**From:** Lasley, Timothy G  
**Sent:** Thursday, July 19, 2018 10:02 AM  
**To:** 'andrew@corecville.com'  
**Cc:** Werner, Jeffrey B; Mess, Camie  
**Subject:** BAR Actions - July 17, 2018 - 550 East Water Street

BAR 17-10-08

550 East Water Street; Tax Parcel 530162300

**CITY OF CHARLOTTESVILLE  
BOARD OF ARCHITECTURAL REVIEW  
STAFF REPORT  
July 17, 2018**

550 WATER STREET  
PROPOSAL FOR MODIFICATION TO C.O.A  
(B.A.R. 15-10-08, C.O.A. GRANTED APRIL 19, 2016)  
JUNE 21, 2018

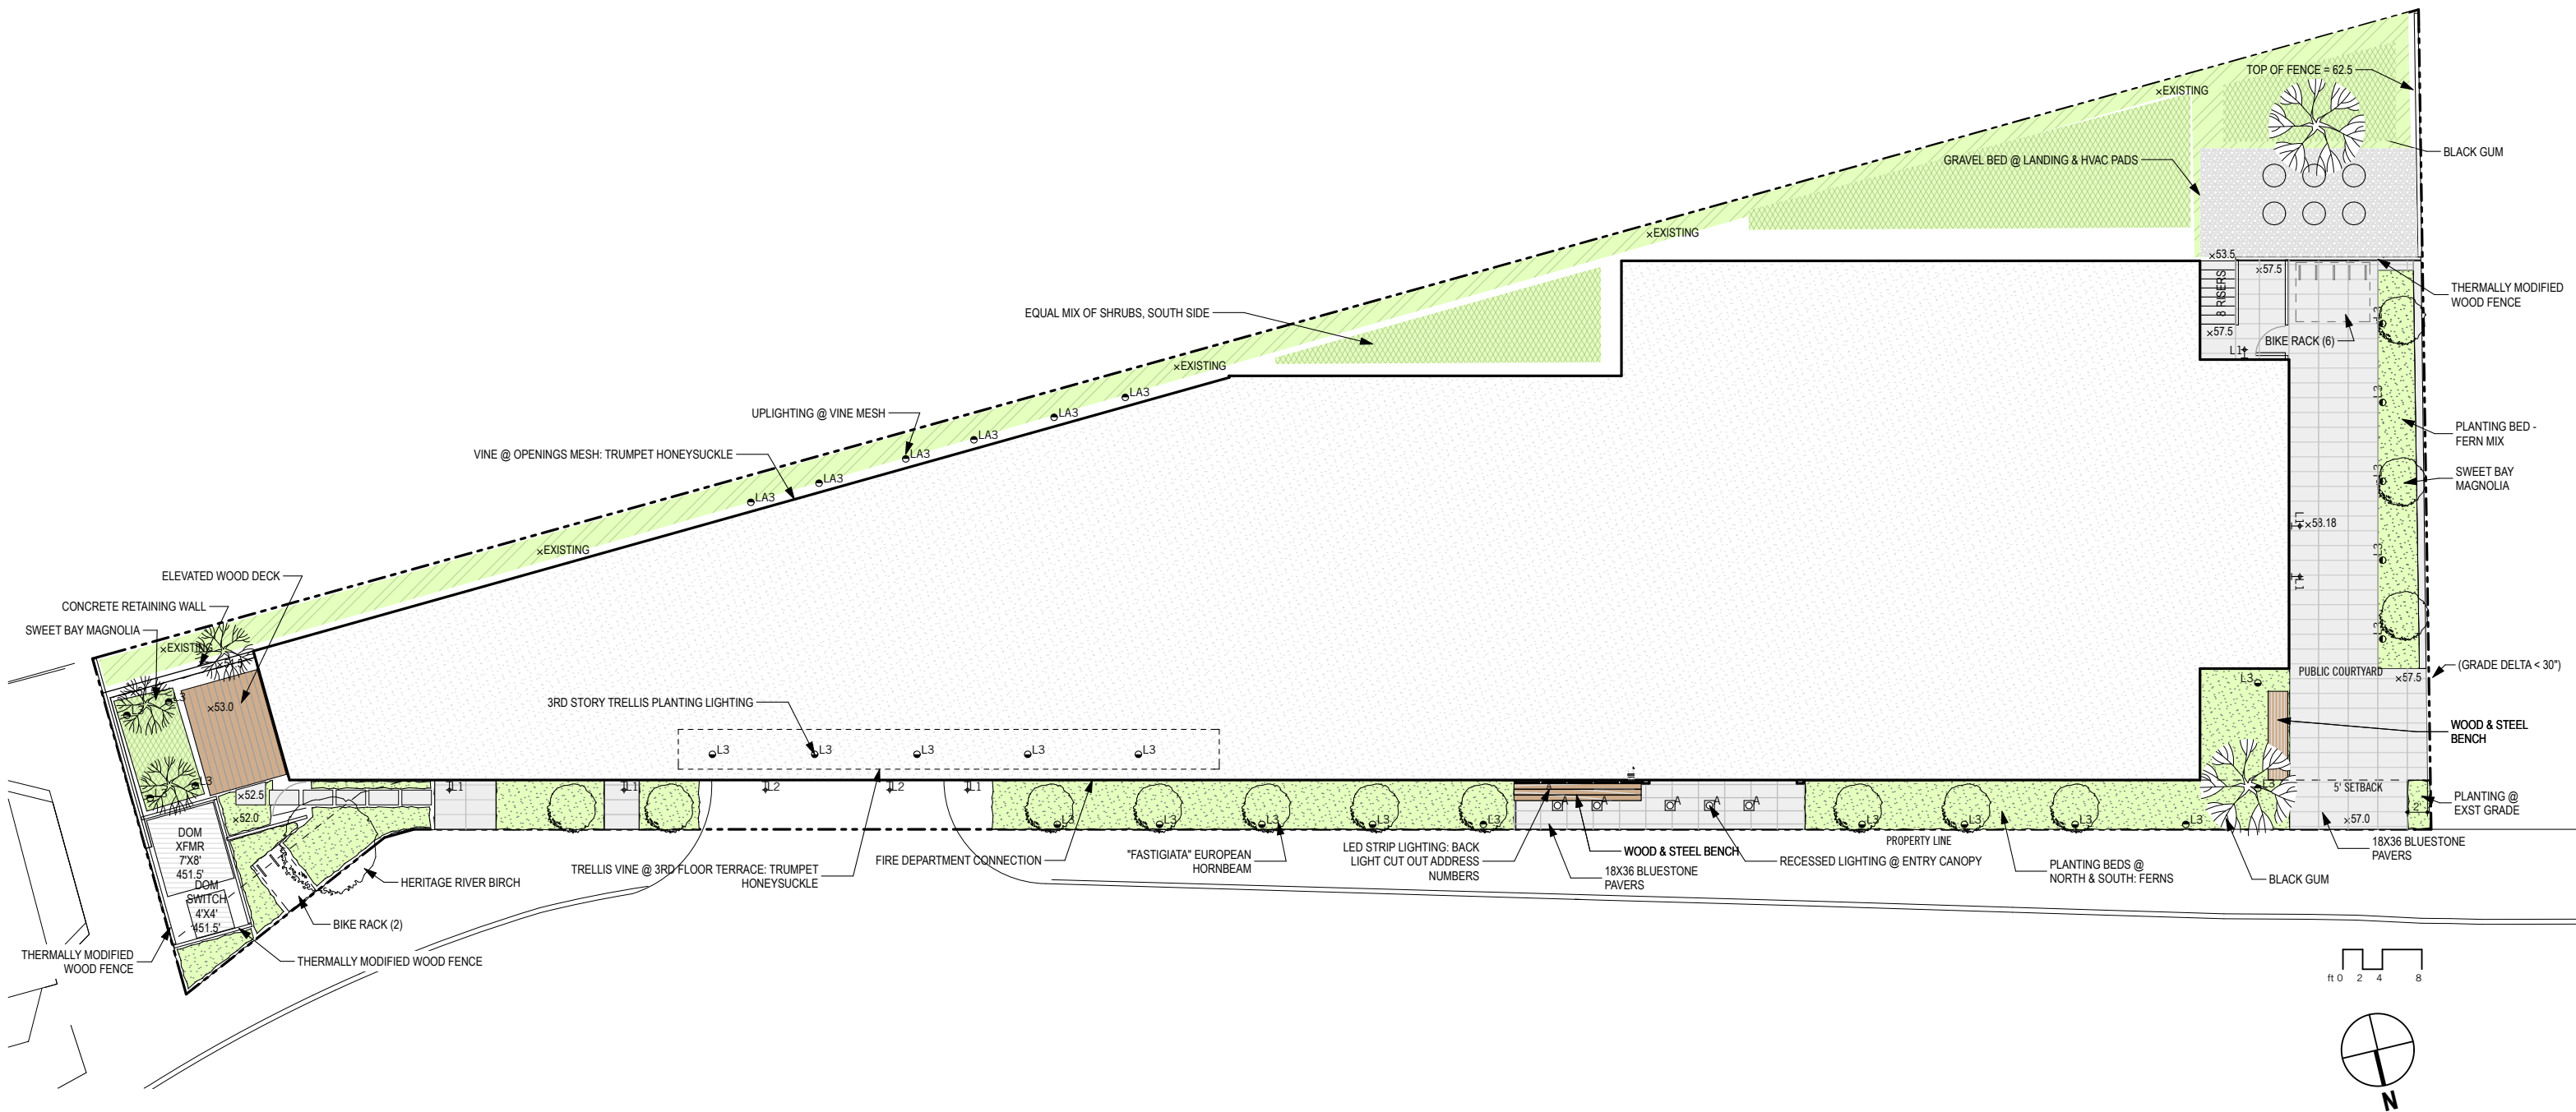
It was noticed late that the elevations used for this application appear to represent a prior version of the building and do not show the final window pattern. However, this discrepancy does not in any way alter the content or context of the proposed ATM lobby. Staff recommends that any motion for approval clearly state the following:

- 2) the base elevations used for this application are obsolete and used here for context only; and
- 3) this COA applies specifically and only to the following alterations at the NW corner of the building:

- a. addition of an exterior entry at the west façade to accommodate street level access for bank office requiring evening ATM access (reconfiguration of the fixed storefront to accommodate the entry door);

- b. extension of bluestone paving to provide access to ATM entry from the public courtyard;
  - c. replacement of the approved Black Gum street tree with a European Hornbeam;

- d. elimination of the wood and steel bench at the public courtyard;
  - e. addition of two, S2 wall sconces on the north facade, matching fixtures approved at other entry locations;

- The understanding that this COA applies only to the addition of an exterior entry at the west façade to accommodate street level access for a bank office requiring evening ATM access; the extension of bluestone paving to provide access to the ATM entry; the replacement of the approved Black Gum street tree with a European Hornbeam; the elimination of a wood and steel bench at the public courtyard; the addition of two S2 wall sconces on the north façade matching fixtures approved at other entry locations; and the interior lighting of the ATM vestibule/lobby, which will include dimmable, recessed fixtures with a color temperature of 3000k, matching nearby exterior fixtures.

- The monument sign must come back to the BAR for review.
- The BAR would like to remind the applicant that all exterior lighting should be reviewed when installed, specifically the location, directions, shielding, and timing of those fixtures.
